TORIN FAN

PART REFERENCE 2507-DE

This bulletin describes the product update resulting from a problem relating to the Torin fan units reference 2507-DE.

Figure 5. 2507-DE data label

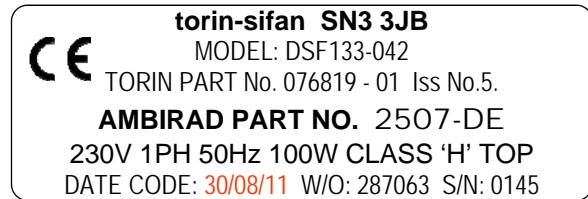
New supplies can also be identified from the date code '**30/08/11**' noted on the data label around the motor cover.
